<b>Notice of Allowability</b>	<b>Application No.</b>	<b>Applicant(s)</b>	
	09/961,245	SUZUKI ET AL.	
	Examiner Guillermo Munoz	Art Unit 2637

### ***Required Correction of Drawings***

FIG. 1

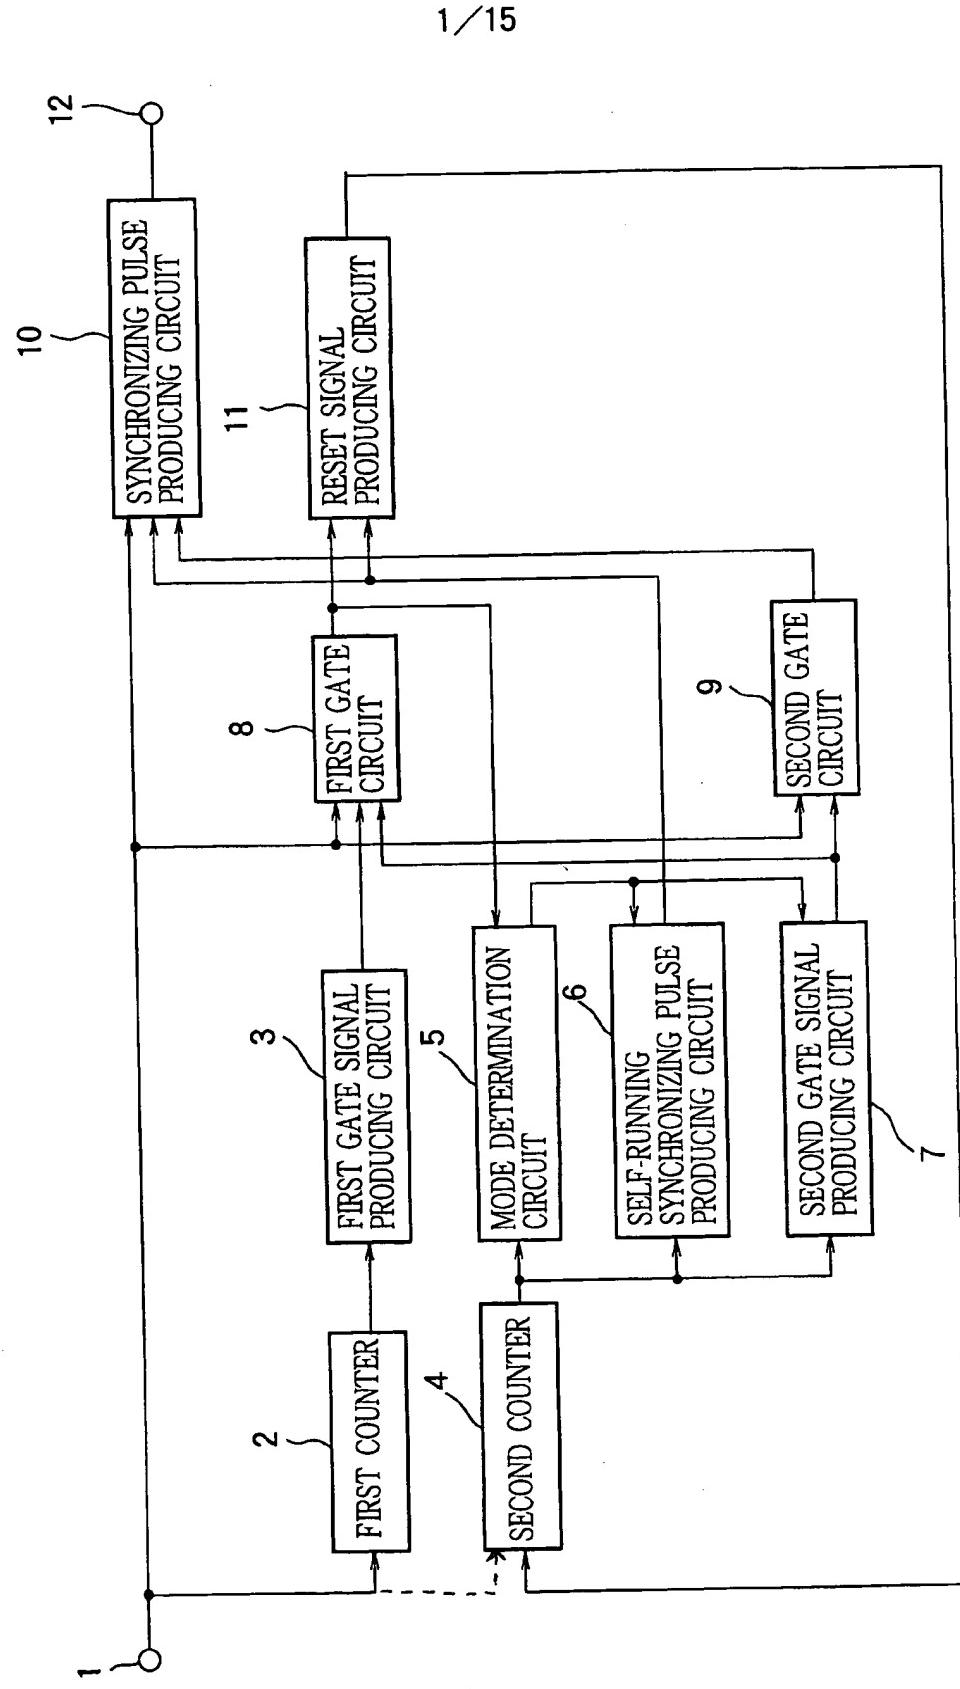
The drawings require modification to include claimed feature “second counter counting the clock” in claim 1 line 14. Figures 1 and 7 have been included in this office action having required changes illustrated by examiner. The corrected Figures 1 and 7 must show the clock of a predetermined frequency input into the second counter. Corrected drawing sheets in compliance with 37 CFR 1.121(d) are required in reply to the Office action to avoid abandonment of the application. Any amended replacement drawing sheet should include all of the figures appearing on the immediate prior version of the sheet, even if only one figure is being amended. The figure or figure number of an amended drawing should not be labeled as “amended.” If a drawing figure is to be canceled, the appropriate figure must be removed from the replacement sheet, and where necessary, the remaining figures must be renumbered and appropriate changes made to the brief description of the several views of the drawings for consistency. Additional replacement sheets may be necessary to show the renumbering of the remaining figures. Each drawing sheet submitted after the filing date of an application must be labeled in the top margin as either “Replacement Sheet” or “New Sheet” pursuant to 37 CFR 1.121(d). If the changes are not accepted by the examiner, the applicant will be notified and informed of any required corrective action in the next Office action. The objection to the drawings will not be held in abeyance.

Drawing Correction

"FIGURE 1" Shown

• Illustrated as broken line arrows
